**Town of Kittery  
Planning Board Meeting  
November 16, 2023**

**ITEM 4 – 77 Bartlett Road – Conservation Subdivision Plan – Preliminary Review**

**RE: Town of Kittery, Planning Board Services  
Bartlett Road Conservation Subdivision Review #3  
77 Bartlett Road, Tax Map 62, Lot 26  
CMA #591.161**

DATE: 5/18/2023  
SCALE: 1" = 80'  
DESIGNED: MTW  
JOB NO.: 22-145  
SHEET: WS-1.0

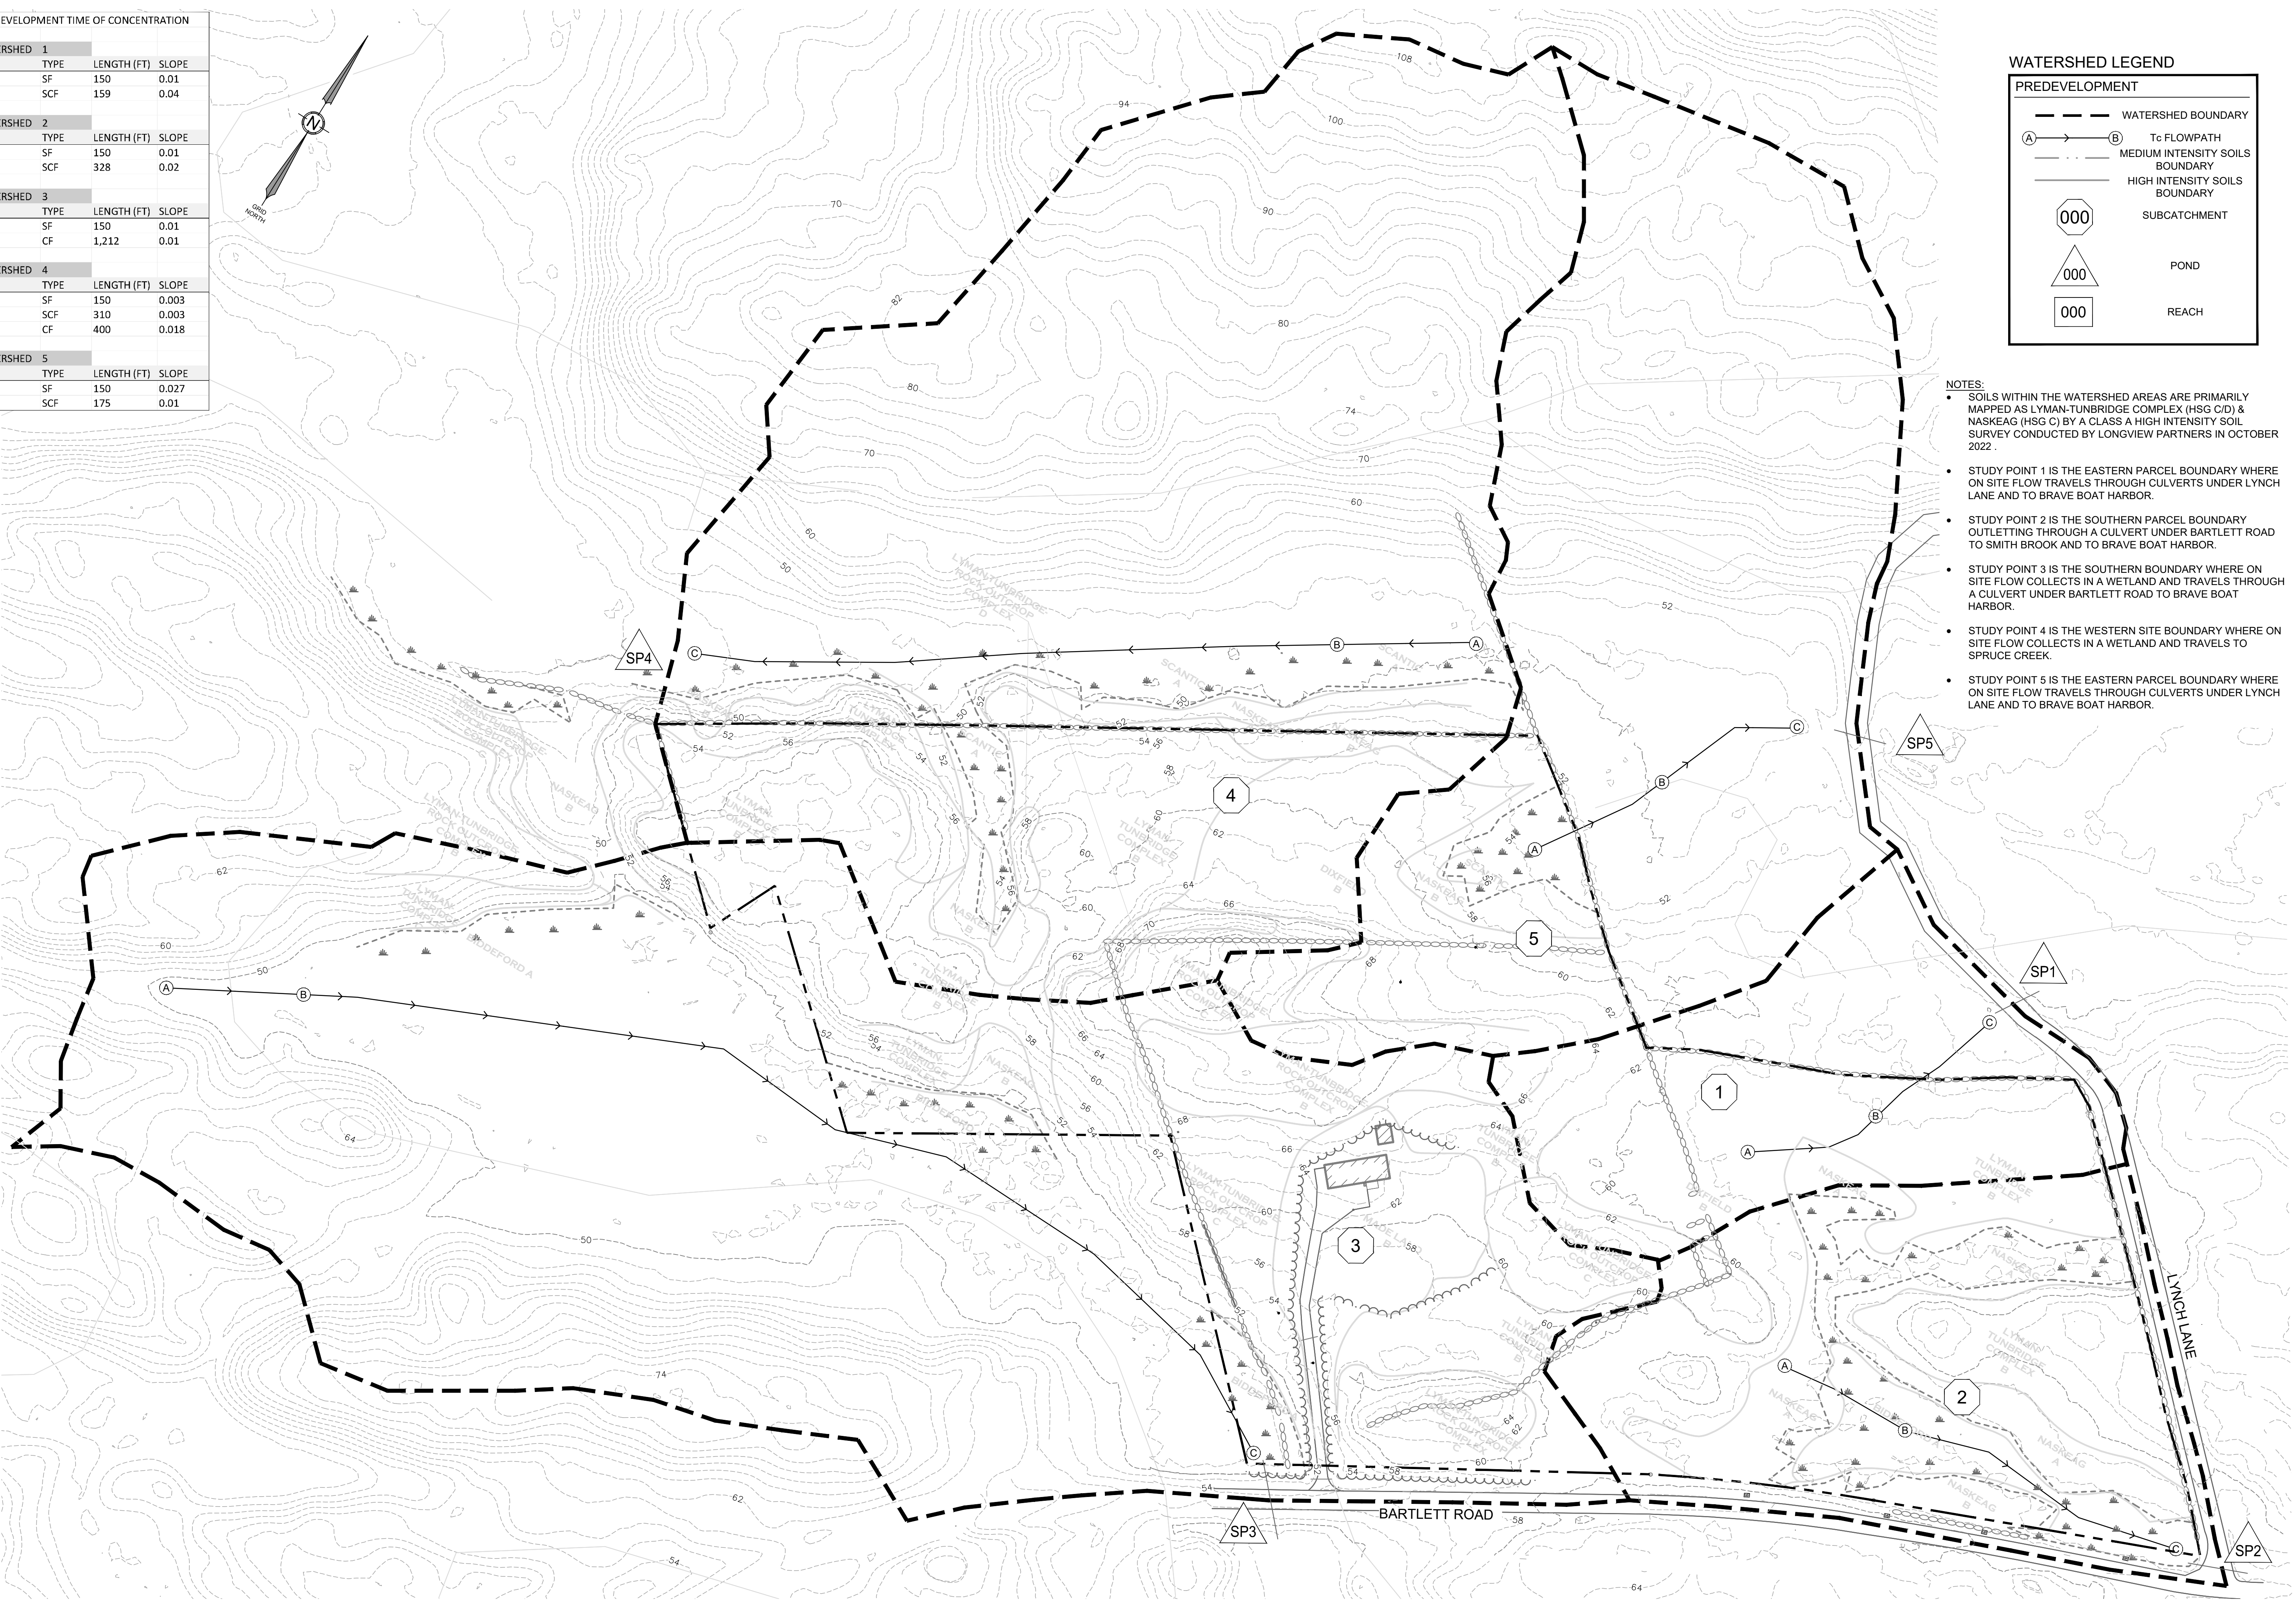
1. Show flow path C-D for watershed 4.

DATE: 5/18/2023  
SCALE: 1" = 80'  
DESIGNED: MTW  
JOB NO.: 22-145  
SHEET: WS-2.0

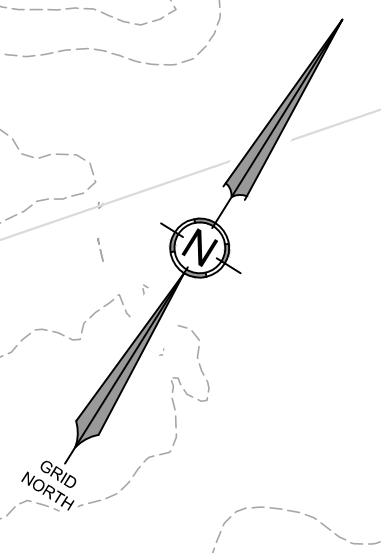
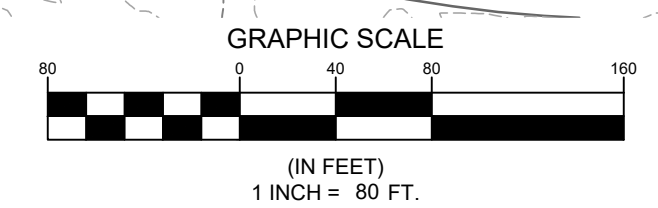
2. Show flow path C-D for watershed 31.
3. Show flow path C-D for watershed 40.
4. Show time of concentration data for watershed 32.

## Culvert Analysis Spreadsheet

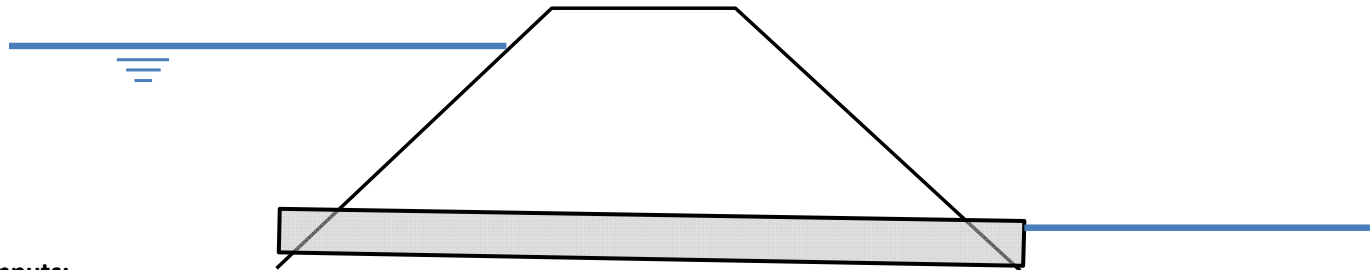
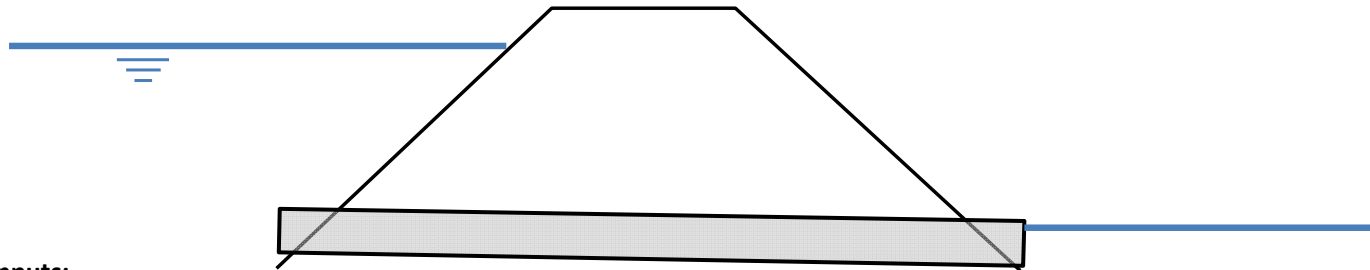
1. Please provide additional information on the culvert sizing calculation. The culverts should be designed to handle a 25-year storm event, but it is unclear what parameters were used in its design.  
**Unaddressed from previous comment letter.**
